## RIIII DINC PEDMIT DEDODT

BUILDING TERMIT REPORT
DATE: 6 APTI 98 ADDRESS: 85 STU a- T ST. (337-C-94)
REASON, FOR PERMIT: 16 CONSTRUCT attached 2 Car garage
BUILDING OWNER: Bernand Shar della
CONTRACTOR: Tom Saunders
PERMIT APPLICANT: Blug, Oune
USE GROUP 4 BOCA 1996 CONSTRUCTION TYPE 573
CONDITION(S) OF APPROVAL
This Permit is being issued with the understanding that the following conditions are met:
Approved with the following conditions: \$\\\\\\\\\\\\\\\\\\\\\\\\\\\\\\\\\\\\
This permit does not excuse the applicant from meeting applicable State and Federal rules and laws.  Before concrete for foundation is placed, approvals from the Development Review Coordinator and Inspection Services must be obtained. (A 24 hour notice is required prior to inspection)
3. Precaution must be taken to protect concrete from freezing.

## LAND USE - ZONING REPORT

ADDRESS: 95 Sturt St DATE: 4/3/98  REASON FOR PERMIT: Convert 6'x 8'mudroom to 24' x 24' garage  BUILDING OWNER: BENAVOL Shandell 2.C-B-L; 3'3'7-C-94  PERMIT APPLICANT: owner  APPROVED: W Ancand trans DENIED:

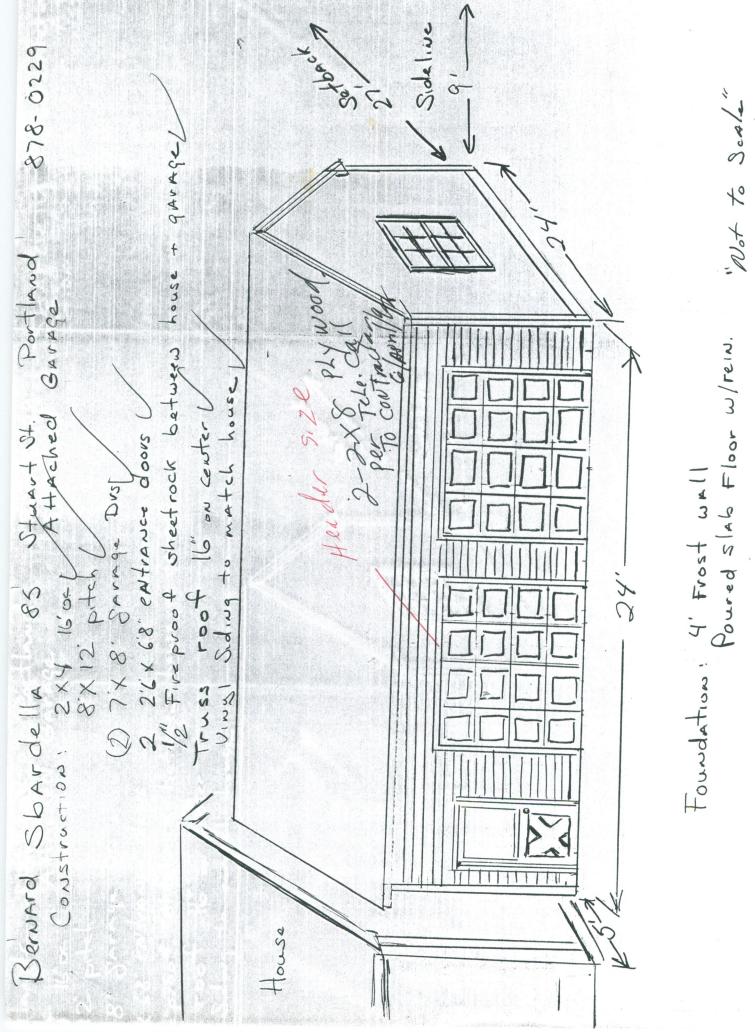
Separate permits shall be required for any signage.  Separate permits shall be required for future decks and/or garage.  Other requirements of condition PloAse Note That The real right
CORNER of your proposed gamage shall be A minimum of 2.5' from The VERV lot line
Marge Schmuckal, Zoning Administrator, Asst. Chief of Code Enforcement
